MAMMOTH CROSSING PROJECT

April 17, 2009

**MAMMOTH CROSSING PROJECT
FINAL ENVIRONMENTAL IMPACT REPORT**

Figure III-5
Site 1 Height Analysis

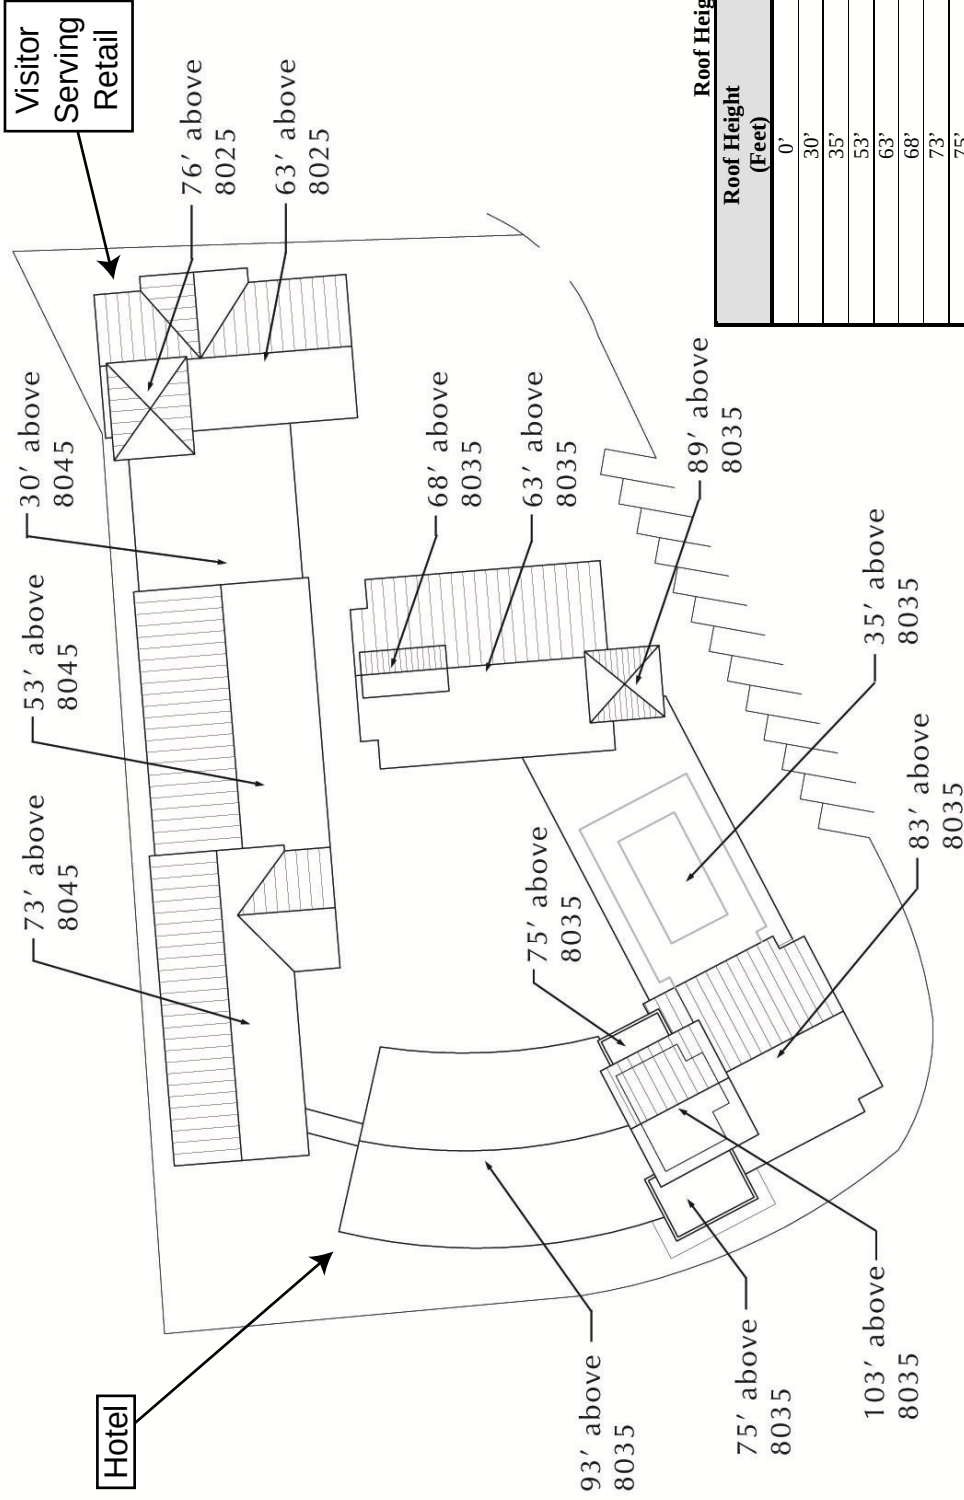
In addition, a major error in calculating percentage of roof area exceeding the maximum permitted has been made in this section of the DEIR. According to our calculations, based on scaling from Figure III-5, the roof area exceeding 50' is actually 81%, not 74%. In the areas calculated in the table on this figure, the building portions with roof heights of 63', and 89' have not been included, and the building heights of 75' have been under-calculated. This means an omission of roughly 10,900 square feet of area above 50'. This means that while the Specific Plan limits height above 40' at 50%, the Project is proposing 81%. It also means that while any increase must be offset by a reduced area of equivalent square footage, only 19% of the entire buildings on Site 1 is below 40'. (Due to time constraints, we have not undertaken to confirm the accuracy of the Height Analysis for Sites 2 and 3. Given the omissions in Site 1, we would request these sites be checked by the proponent.)

The roof area calculations have been revised to reflect that the Project development on Site 1 would exceed the 50-foot maximum height requirement by 78 percent and not 74 percent as identified in the Draft EIR. The roof area calculations for Site 2 and Site 3 were reviewed and found to be accurate, therefore no changes are required. In response to this comment Figure III-5, Site 1 Height Analysis, on page III-9, of the Draft EIR has been revised and is included in Section III, Corrections and Additions, to the Draft EIR. This revision does not affect any conclusions or significance determinations provided in the Draft EIR.

As noted in Response to Comment B13-9, Figure III-5, Site 1 Height Analysis, on page III-9 of the Draft EIR has been revised and is included in this Final EIR.
